STUDIOMASTER DIAMOND LTD		TITLE		AMPLIFIER AMP CIRCUIT		FILE NAME	
PRODUCT		700D 900E PHV PHF		PART 1 OF 1		R1C5-4.DGM	
VERSIONS		ALL MODELS		DRN BY		P.A. DATE 06-09-99	
						ISSUE No	
						R1C5-4	
						REV5

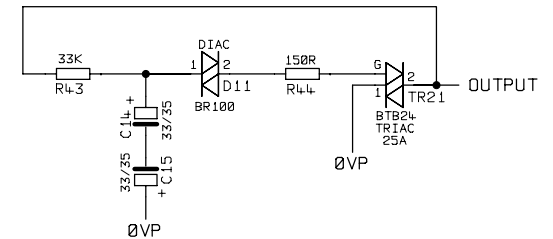
REV3 = R4.7 & R50 CHANGED FROM 220R 5% TO 220R 5% FUSIBLE  
R4 CHANGED FROM 1K2 5% TO 1K5 5%  
REV4 = R4.5, R4.8 33k 5% REMOVED  
R4.6, R4.9 CHANGED FROM 5K6 TO 2K7 5%  
REV5 = 900E ADDED TO RANGE, R4.6 & R4.9 CHANGED FROM 2K7 TO 15K  
R4.7 & R50 CHANGED FROM F220R TO F1K (FUSIBLE),  
R35, R36, R37, R38 CHANGED FROM 0R22 ROX35 TO 0R18 ROX35
